**JOINT REGIONAL PLANNING PANEL
(Eastern Region)**

JRPP No	2011SYE086
DA Number	DA/974/2010/A
Local Government Area	Randwick City Council
Proposed Development	Section 96 modification to approved aged care development by changing the unit mix to provide additional 1 bedroom dwellings with an overall increase in unit number by 7; increasing basement parking by 9 spaces; increasing envelopes of Buildings 3 & 4; amending facade configuration; amending roof design; amending stormwater management design and various modifications to existing conditions at 220-230 Maroubra Road, MAROUBRA NSW 2035
Street Address	220-230 Maroubra Road, MAROUBRA NSW 2035
Applicant/Owner	Greengate Development Pty. Ltd/Trustees Roman Catholic Church
Number of Submissions	None
Recommendation	Approval
Report by	Senior Environmental Planning Officer – Randwick City Council

1. EXECUTIVE SUMMARY

PANEL RECOMMENDATION

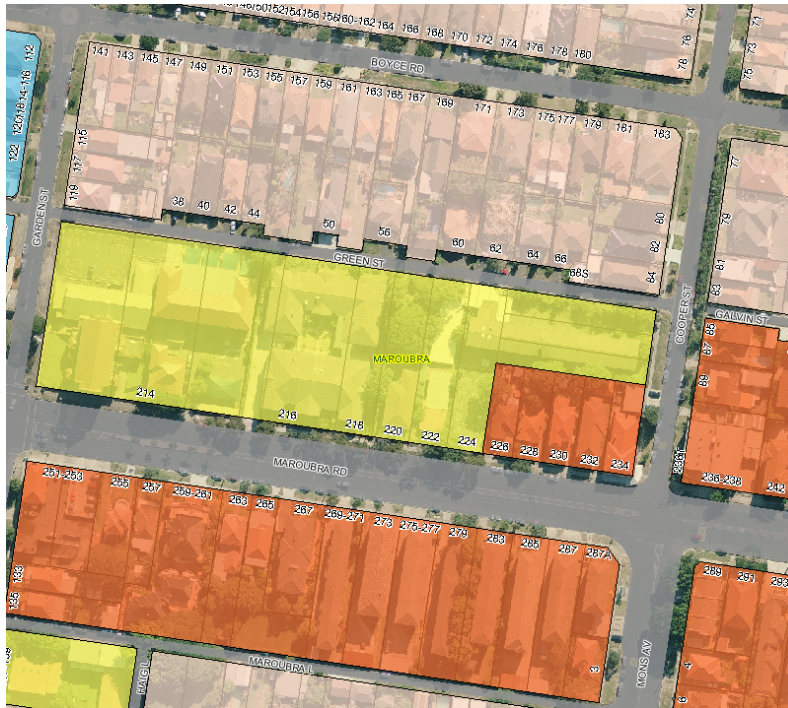
- The planning arrangements in these new apartment layouts could be improved by providing a window to the kitchen, rearranging the study, laundry and entry to work off one circulation space (in an L shape as one possibility) and making the area around the bed more generous. The living room by comparison is large.

If these sunshading and internal planning issues are addressed satisfactorily in consultation with the Council Officers the Panel does not need to review this application again.

Planners comment: The proposed apartment layout is considered to be acceptable in providing a reasonable level of amenity for future occupants.

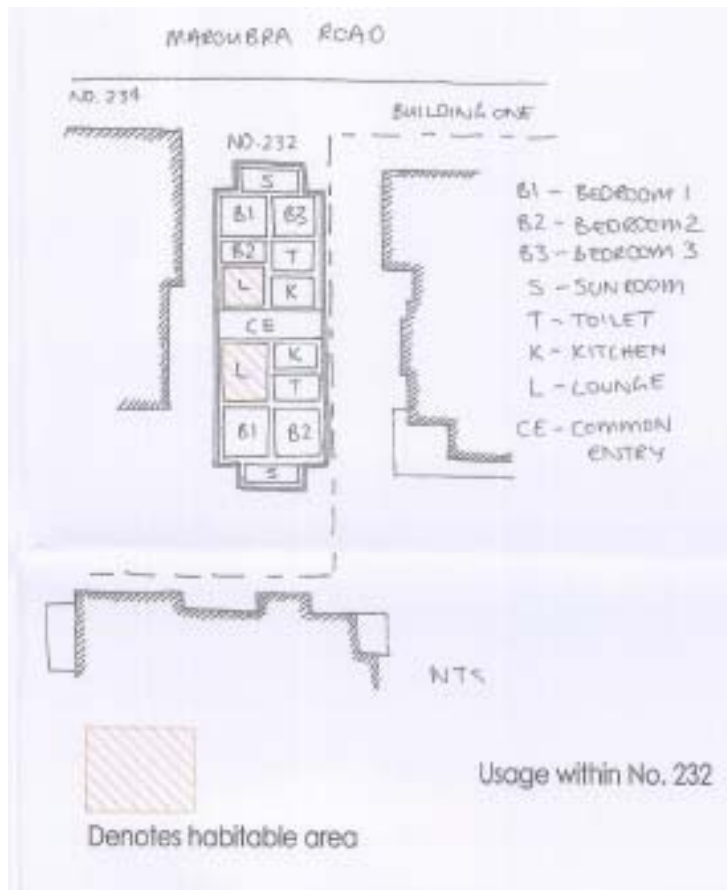
The expected shadow impacts of the proposed modifications on the adjoining property to the south are as follows:

The proposed modifications are not anticipated to generate a significant amount of overshadowing to the northern side of No. 232 Maroubra Road to the south of the site (more specifically to the south of ILU Building 4). The additional unit proposed under the current Section 96 application does not generate additional and unreasonable overshadowing due to the following reasons: -

- The modifications Building 4 form resultant from the internalisation of the lift core to the north facing apartments is effective in alleviating overshadowing impacts which would otherwise result from the additional of Unit 15.
